Errata

J721S2, TDA4VE, TDA4AL, TDA4VL, AM68A Processor Silicon Revision 1.0

ABSTRACT

Figure 3-1. Bug Condition

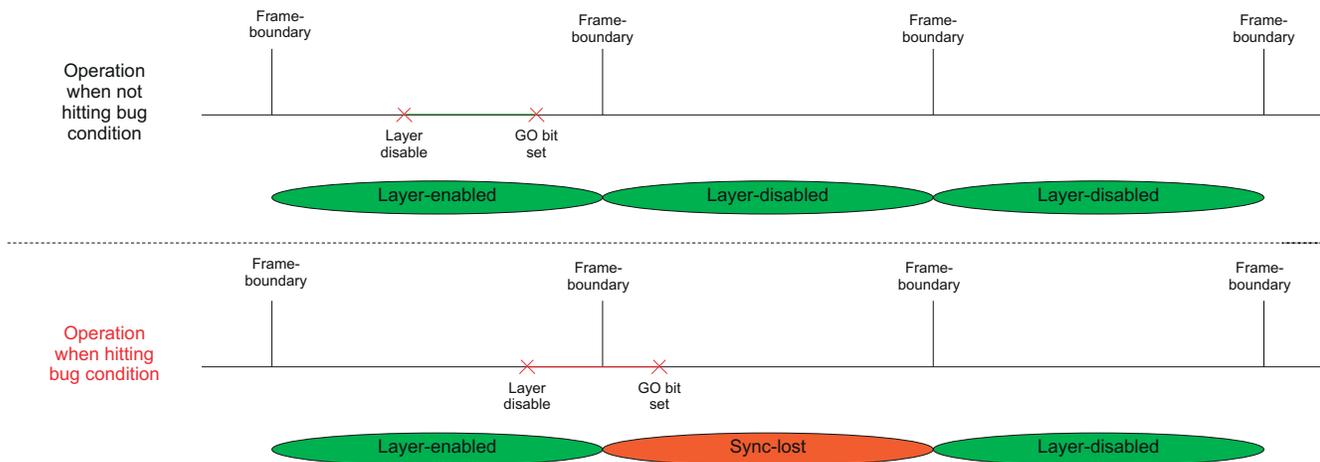
i2097 DSS: Disabling a Layer Connected to Overlay May Result in Synclost During the Next Frame

Details: Disabling a layer (for example VID1) connected to an OVR (that is toggling DSS_VID_ATTRIBUTESx[0] ENABLE from 1 to 0) may result in synclost during the next frame. The synclost may result in a corrupted or blank frame (all pixel data sent out of DSS during the frame is 0x0). The occurrence of synclost is dependent on the timing of setting the GO bit (that is DSS_VP_CONTROL[5] GOBIT to 1) vis-à-vis the disabling of the layer. If the “disable layer” MMR write operation and “set GO bit” MMR write operation happens within the same frame boundary, no synclost occurs. If the operations happen across the frame boundary, then synclost occurs (for one frame). The design automatically recovers and returns to normal operation from the next frame after GO bit is set, see [Figure 3-1](#).

Workaround(s): A simple software workaround exists. In the workaround, prior to disabling a layer on the OVR, it is moved to the “non-visible” area of the OVR (for example: `DSS_OVR_ATTRIBUTES_x[17-6] POSX = max_value_of_posx` or `DSS_OVR_ATTRIBUTES_x[30-19] POSY = max_value_of_posy`). This avoids the synclost when the layer is disabled.

Figure 3-4. MDIO Emulation via Manual Mode using PRU Core

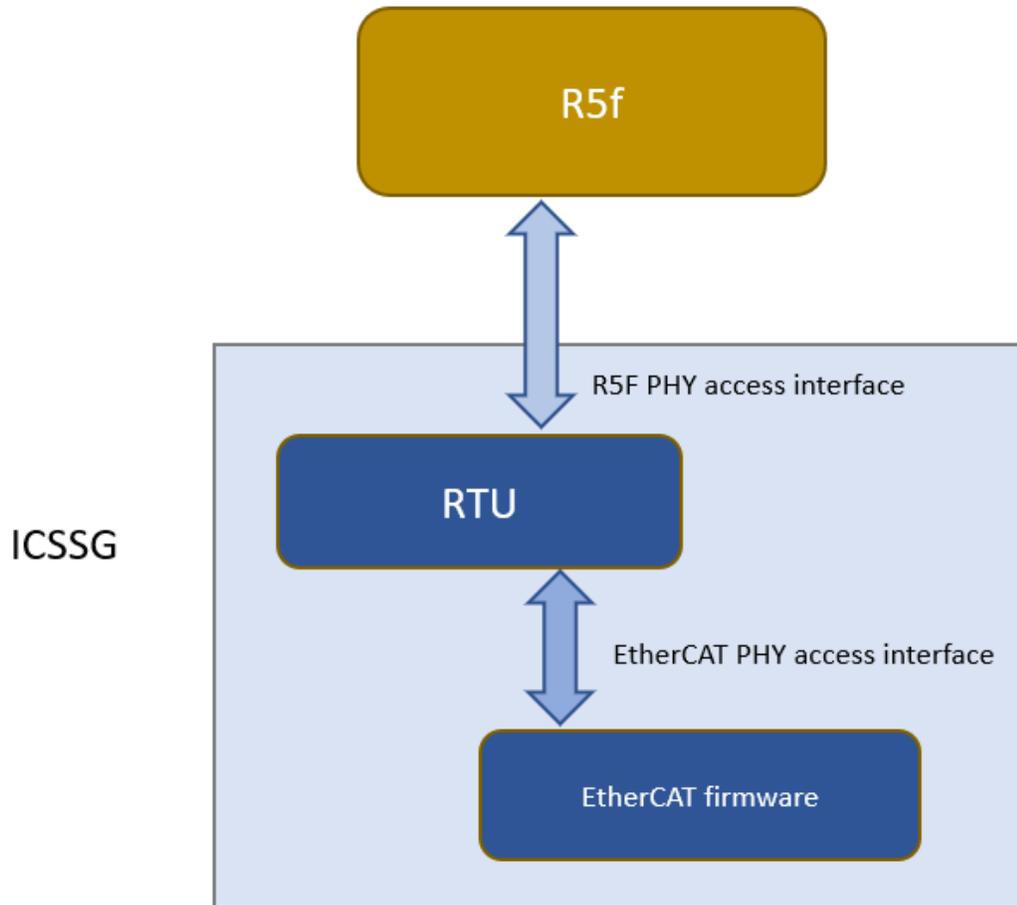
i2329 (continued) MDIO: MDIO interface corruption (CPSW and PRU-ICSS)

EtherCAT will continue to use PHY fast link detection via MDIO MLINK bypassing state m/c for link status (as this path is not affected by errata). This makes sure that cable redundancy related latency requirements are still met.
